## HILL VALLEY - PHASE 2B

CITY PROJECT NO. 15860  
CONTRACT NO. 9680

#### REVISION 1 - 04/29/26

#### REVISION 2 - 05/28/26

TYPICAL SECTIONS (EXISTING)  
HILL VALLEY - PHASE 2B  
M:\DESIGN\Projects\15860\CAD\Streets\15860EN-Details.dwg

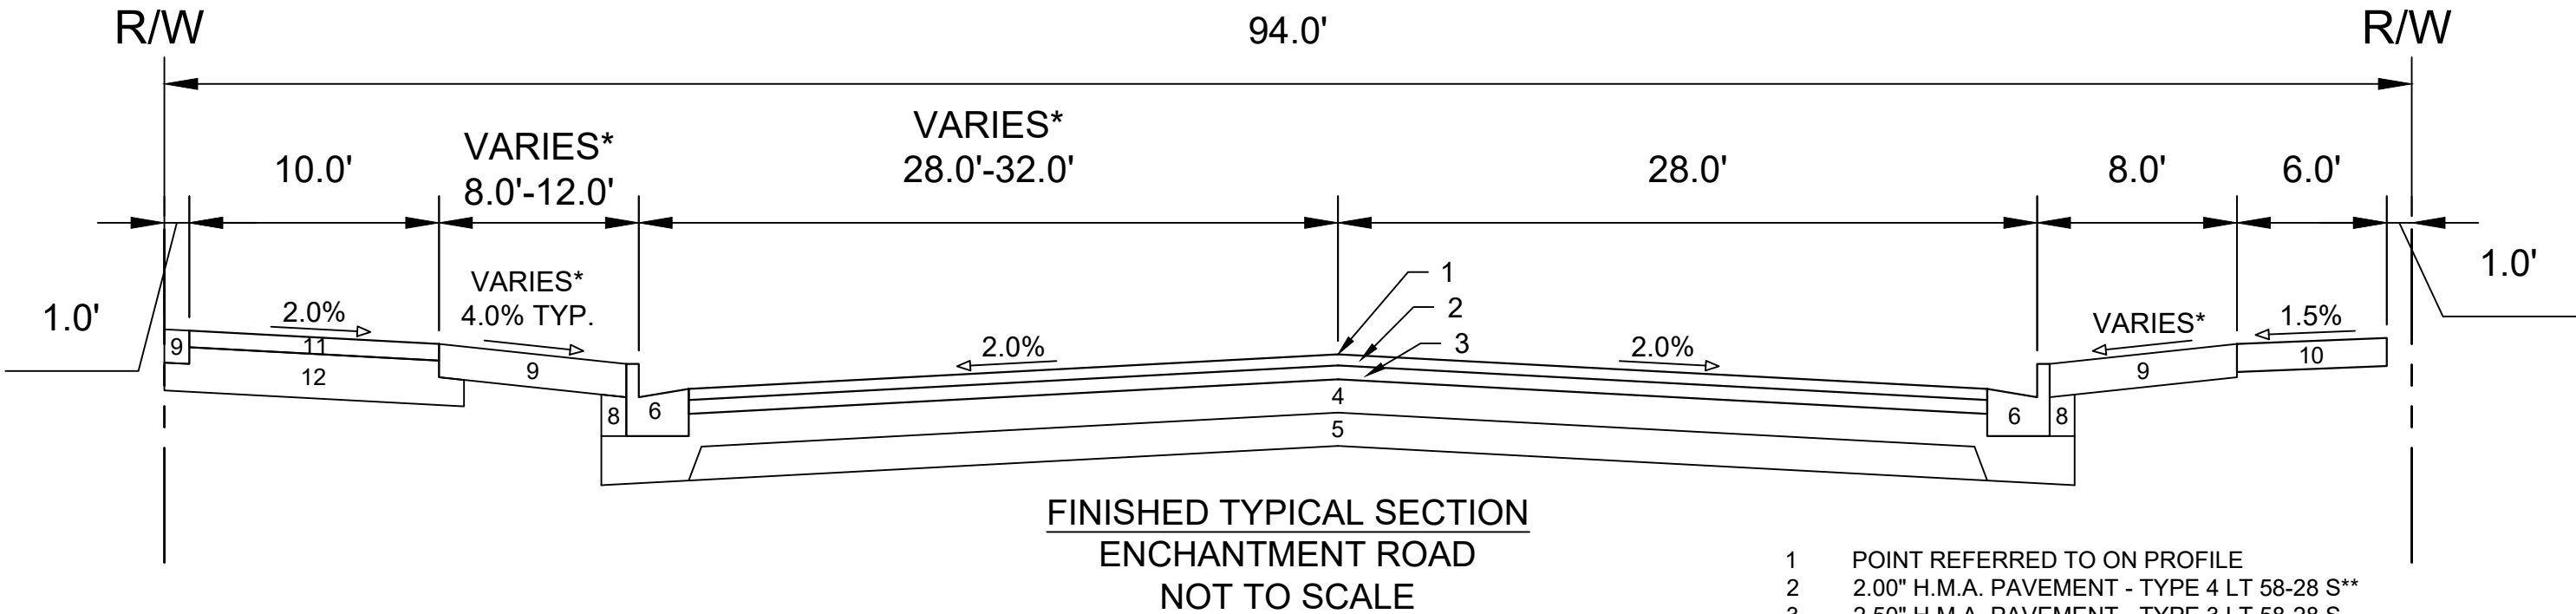
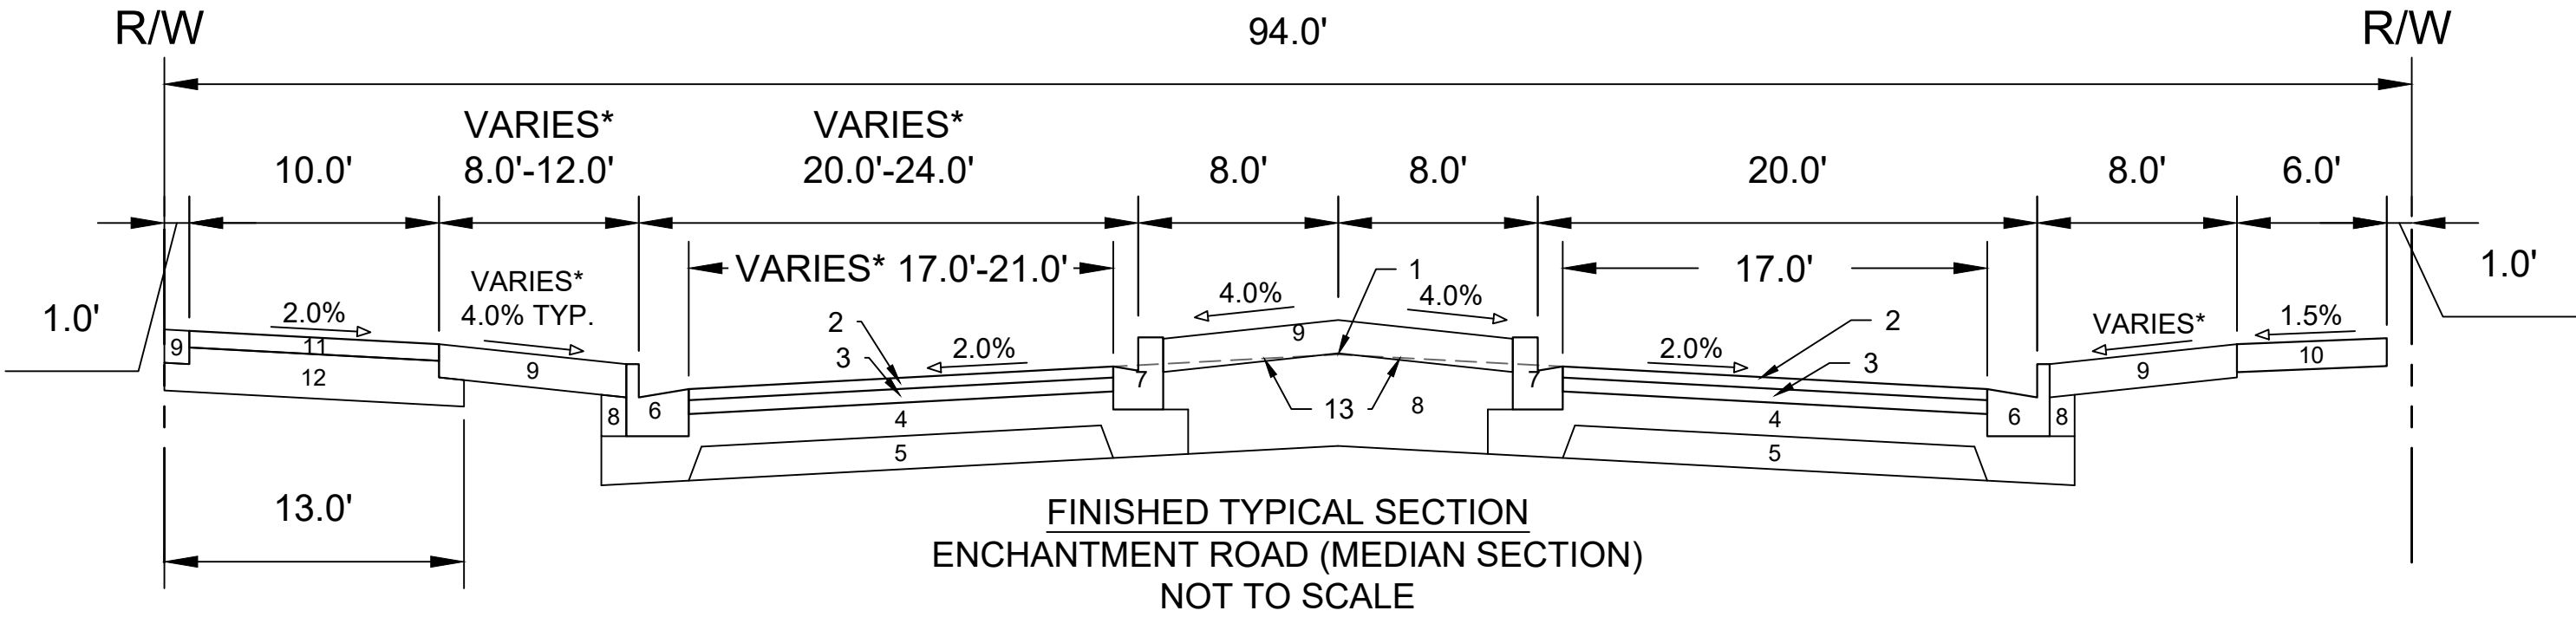
**REVISION 2 - GCIT - 05/28/26**  
- EXISTING TYPICAL SECTIONS ADDED

15860  
 O-1

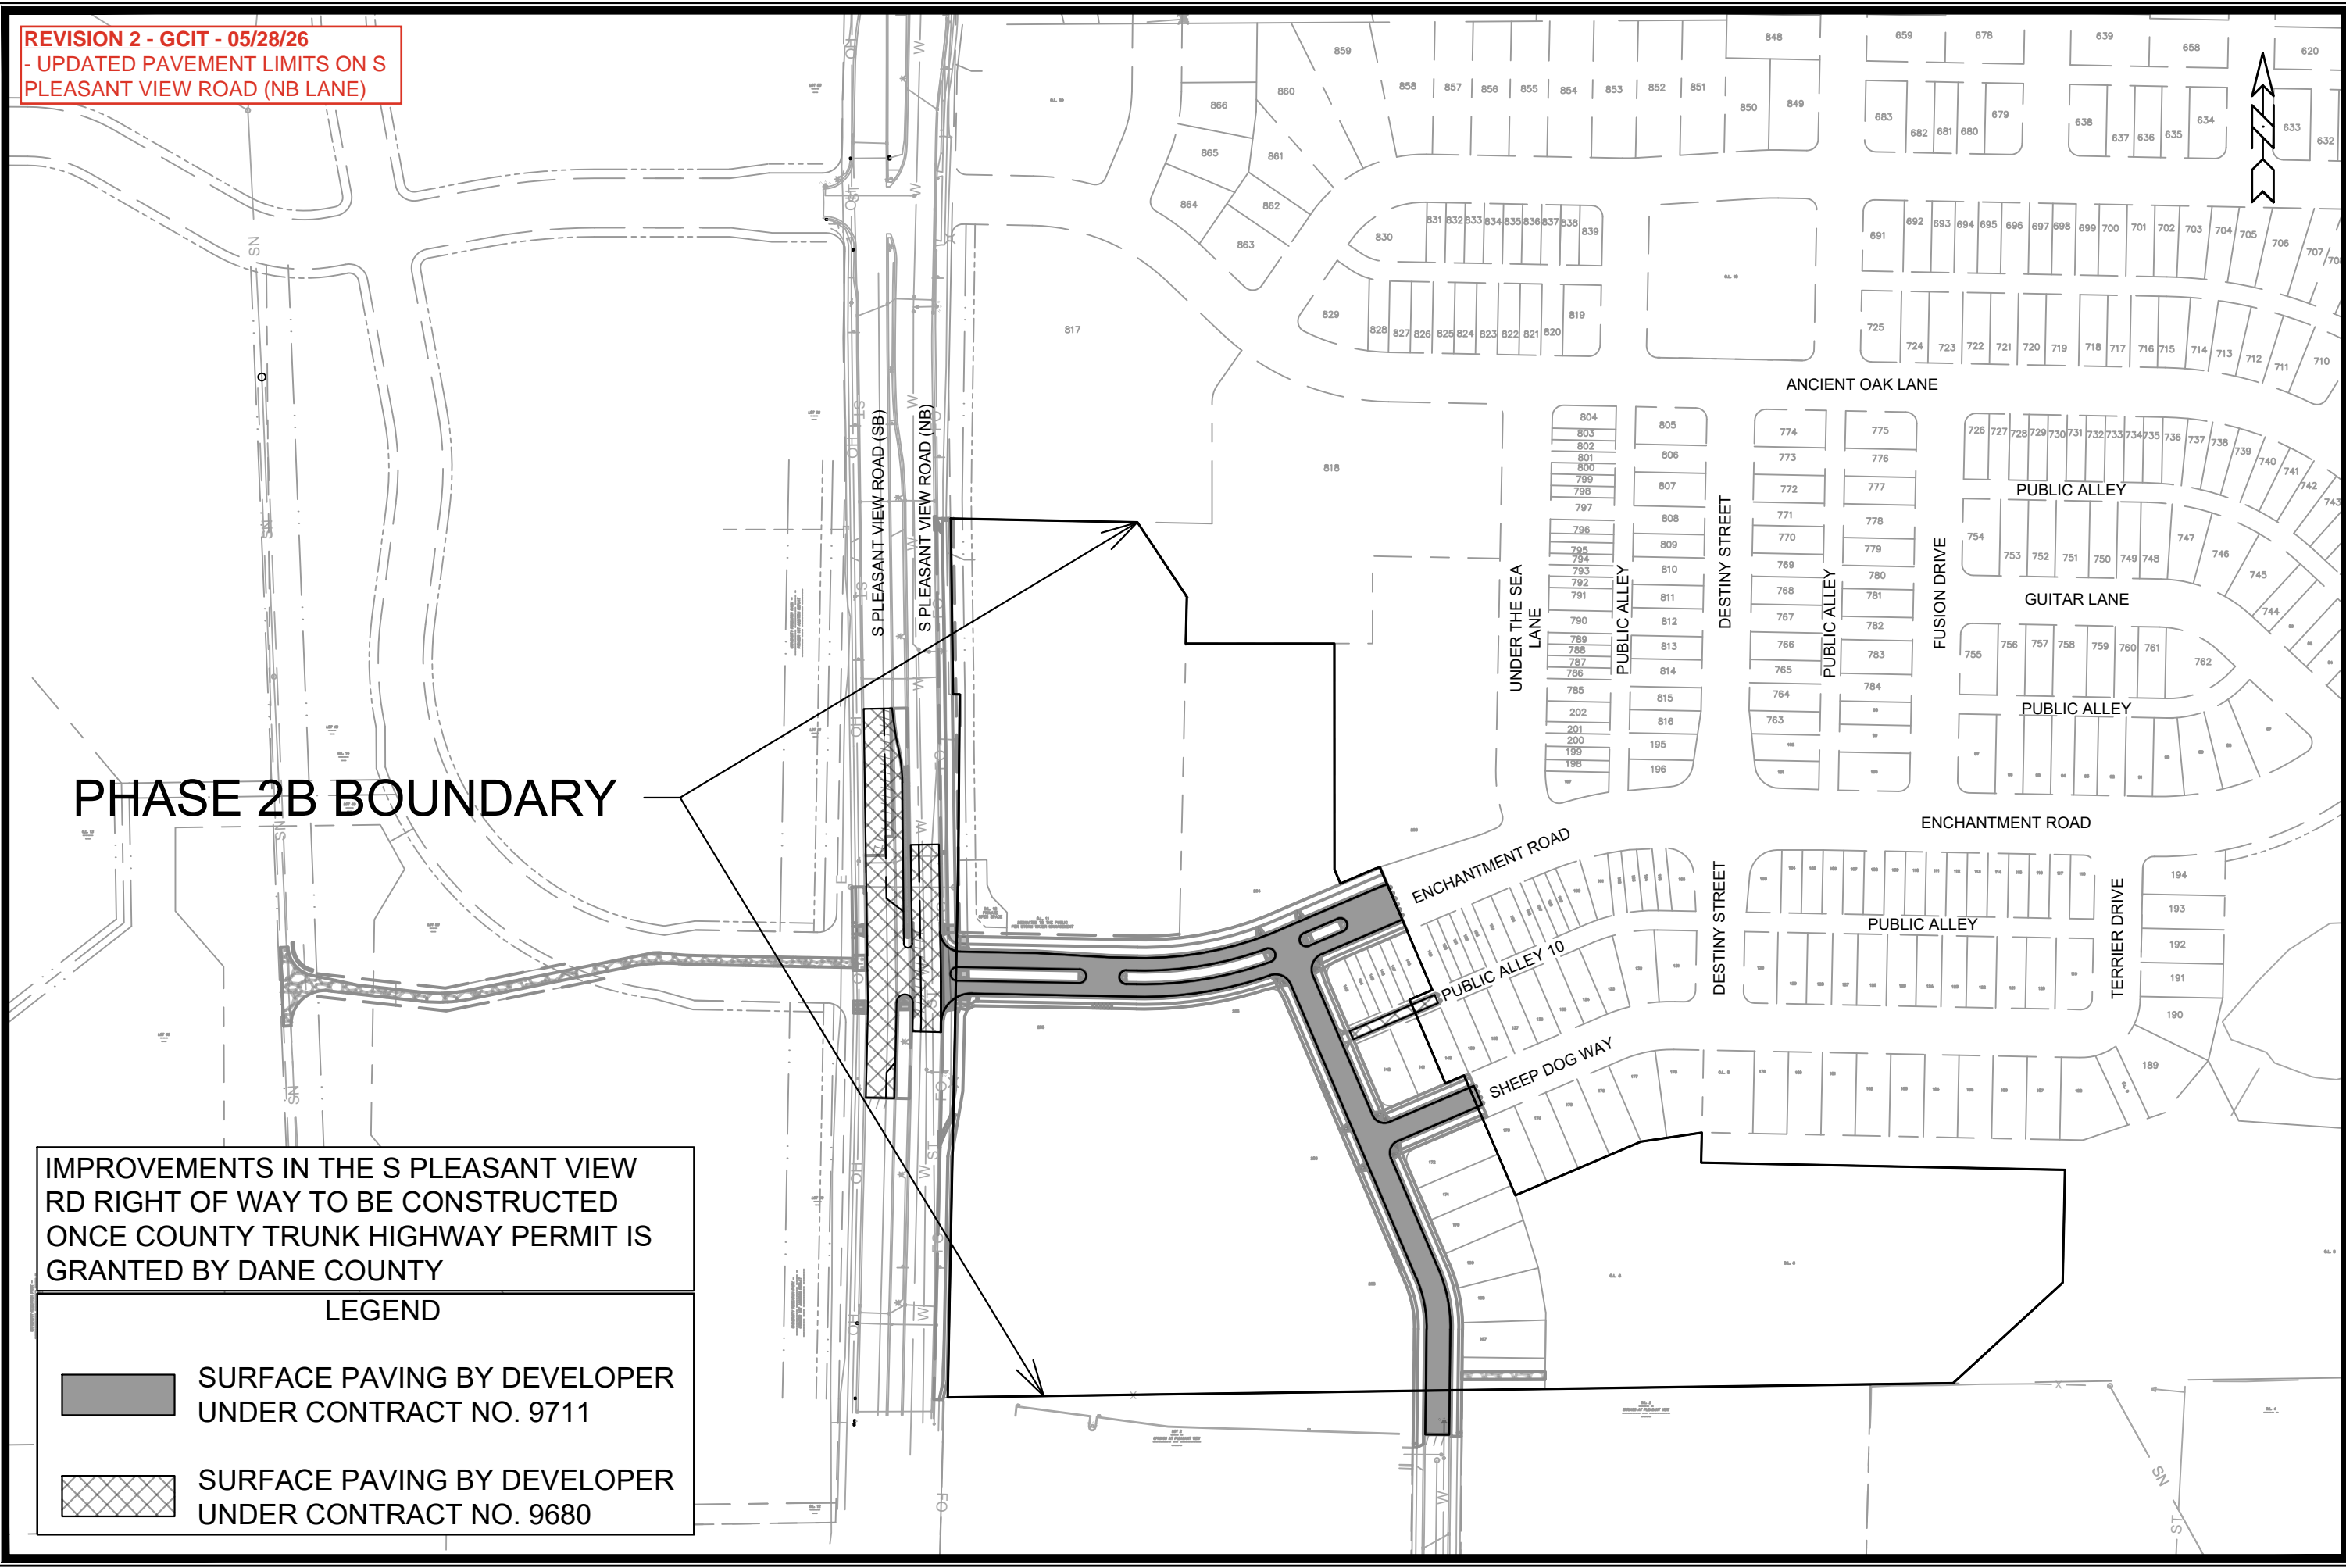
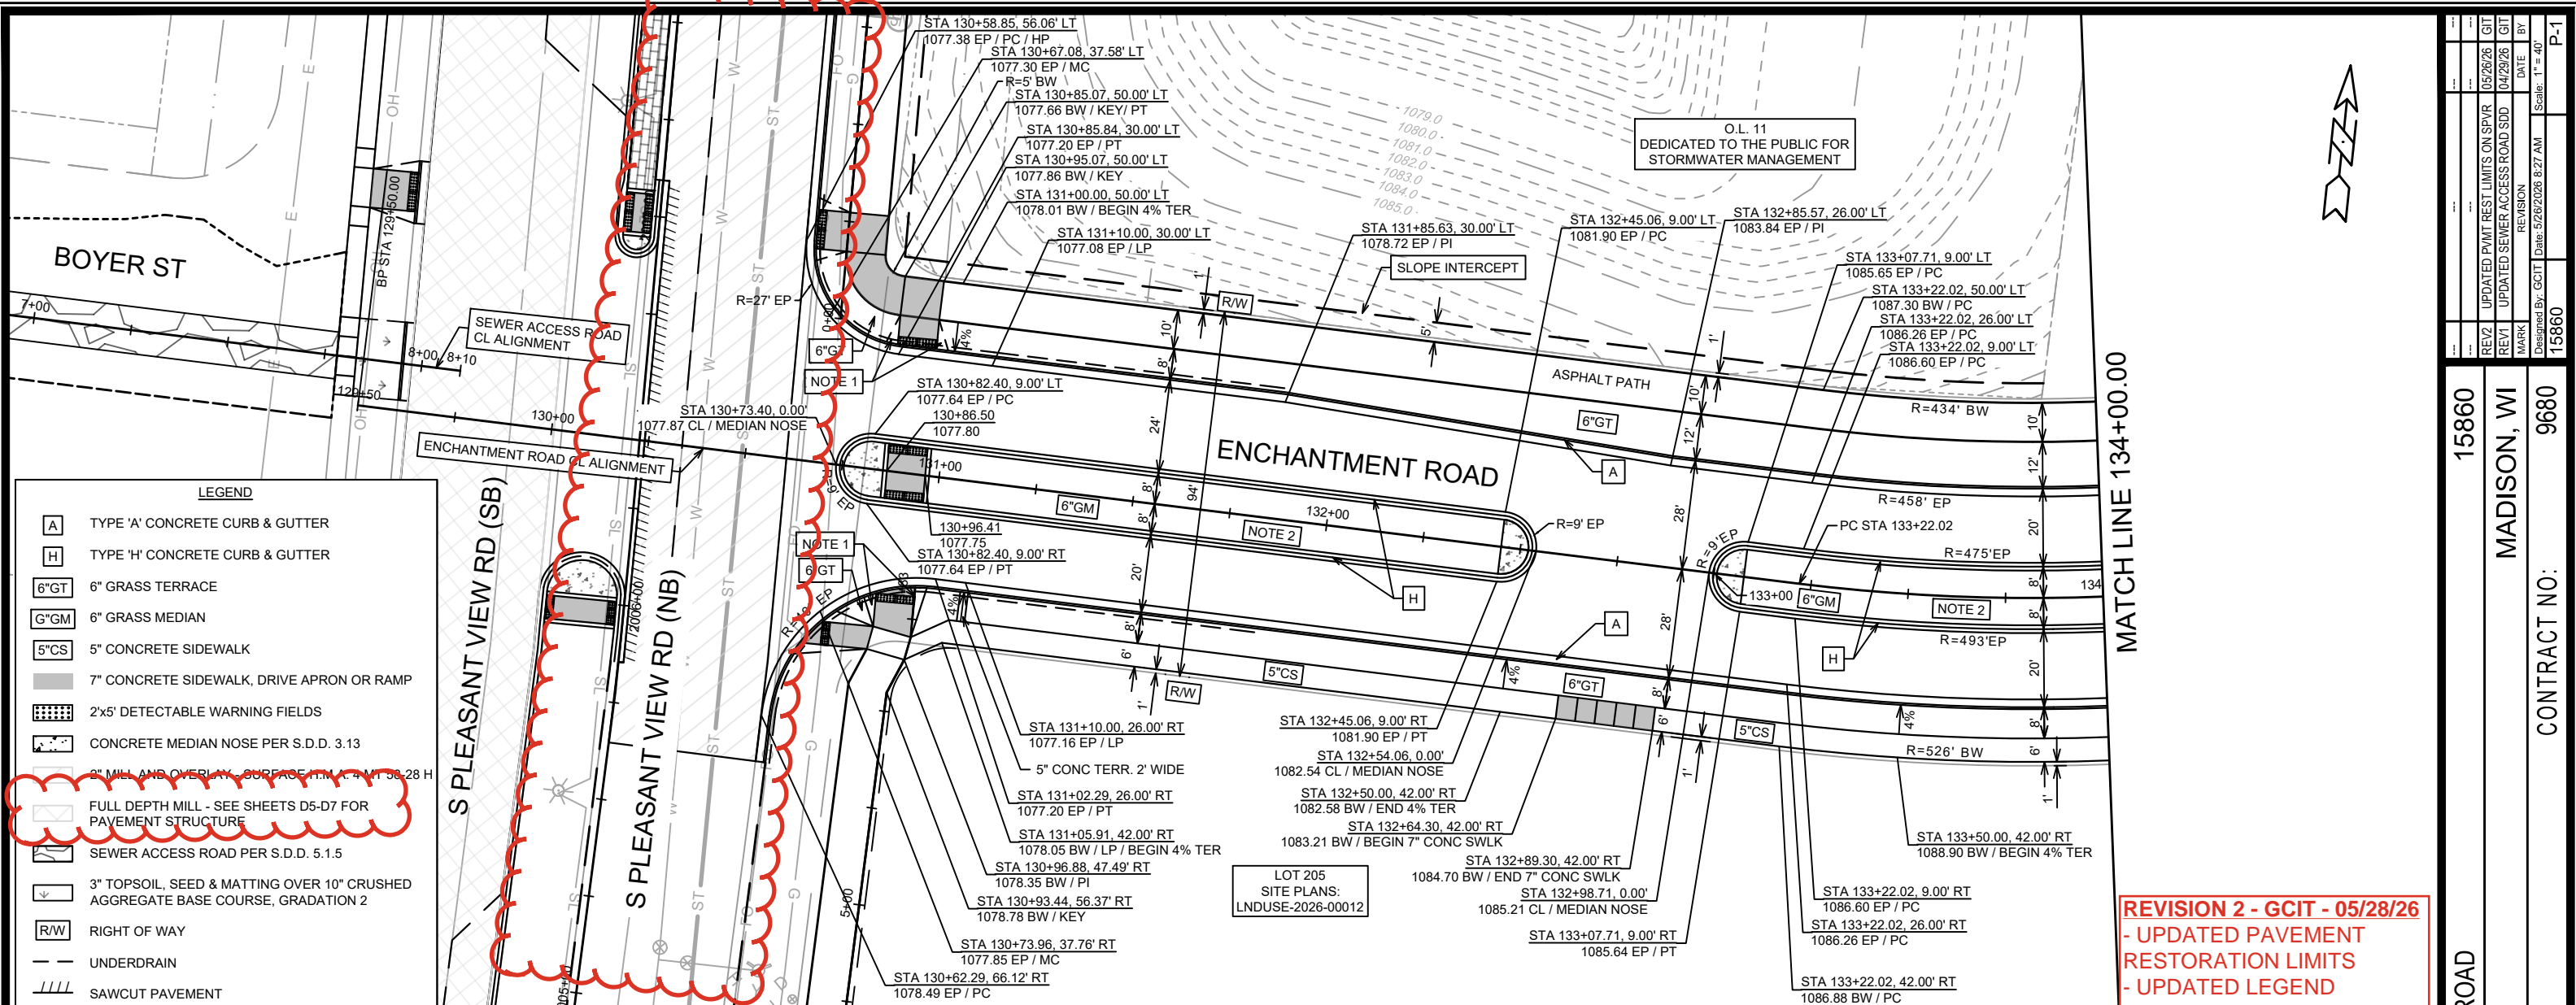
**REVISION 2 - GCIT - 05/28/26**  
 - UPDATED PAVEMENT LIMITS ON S PLEASANT VIEW ROAD (NB LANE)
